Product Change Notice (PCN)

PCN Number: PCN-0374437R-01

Product(s) Affected: *CS-3603, CS-3606, CS-3612 & CS-3624*

Top	Side	Bottom
CS-36XX Old			
CS-36XX New

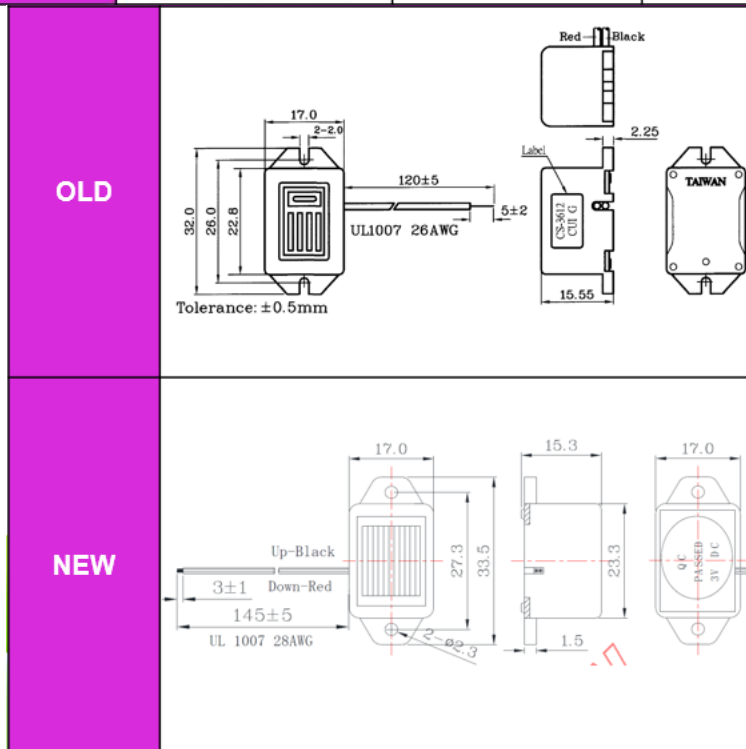
Description of Change: *Current consumption has decreased by 10mA on CS-3603 & CS-3606, it has increased by 5mA on CS-3612 & increased by 11mA on CS-3624. Operating voltage on CS-3624 has a new minimum of 18VDC. SPL has been increased by 3dB on CS-3603, CS-3606 & CS-3612. SPL has been increased by 2dB on CS-3624. Operating temperature on all four models has been widened to -30~70°C. Storage temperature on all four models has been shifted to -35~75°C. Some dimensional changes & elongated sound holes (shown in drawing below).*
